## ***Planning Application Representation***

# **OBJECTION AND COMMENTS ON CLIMATE CHANGE ISSUES**

**Ford Circular Technology Park, Ford Road, BN18 0XL**

**WSSCC/011/21**

**COMPARISON OF FOSSIL CARBON INTENSITY OF ENERGY EXPORTED TO THE GRID  
FROM DIFFERENT ELECTRICITY GENERATION METHODS (GCO<sub>2</sub>E /KWH)**

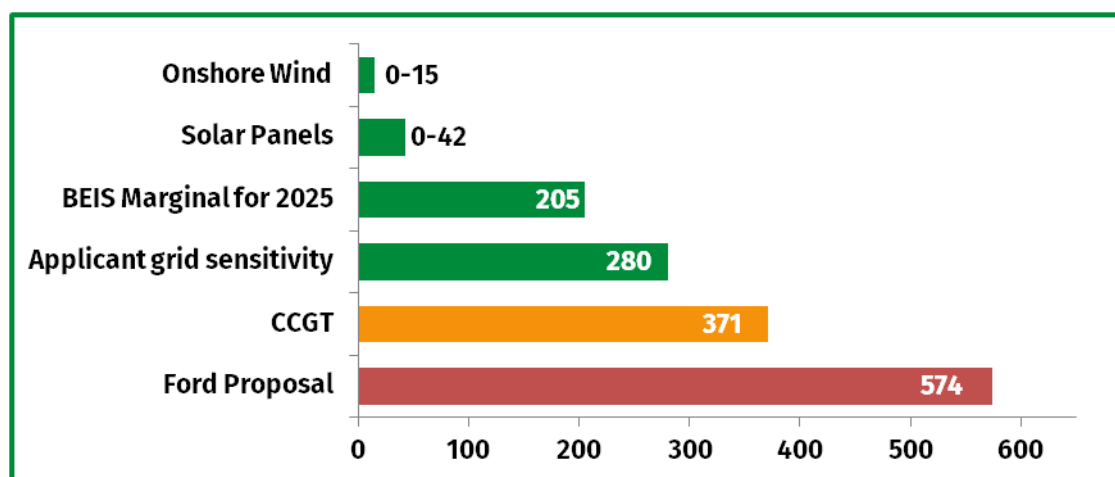
10. As shown below and overleaf, the figure of 574g CO<sub>2</sub>e per kWh (which is based on the applicant's planning application data) would mean that the development would have a significantly higher carbon intensity than:

- a) The conventional use of fossil fuels (CCGT), which the applicant assumes is 371g of CO<sub>2</sub> per kWh in ES Section 7.91 and Table 14 of ES Technical Appendix D1 (which is currently used as the applicant's central assumption for the applicant's grid displacement factor);

- b) The applicant's grid displacement factor sensitivity figure of 280g CO<sub>2</sub> per kWh as noted in ES Technical Appendix D1 Table 14;
  - c) The BEIS Long-run Generation-based marginal grid displacement factors for 2025 (205g CO<sub>2</sub> / kWh)<sup>1</sup>; and

- d) Genuinely low carbon sources such as solar and wind which have very low emissions even when construction impacts are taken into account.<sup>2</sup>
